Subject: UTS size 8 Jam nut modification.

Product Part Number: UTS78__

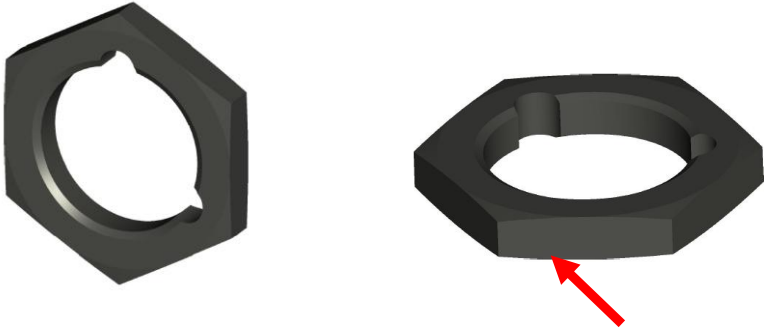
Description of Change: The current version of the jam nut is rolled and it will be replaced by a machined version instead.

Current:

New:

There will be no impact in regards to form or fit. However function will be slightly different, as there will be no way of attaching a lanyard to the chassis.
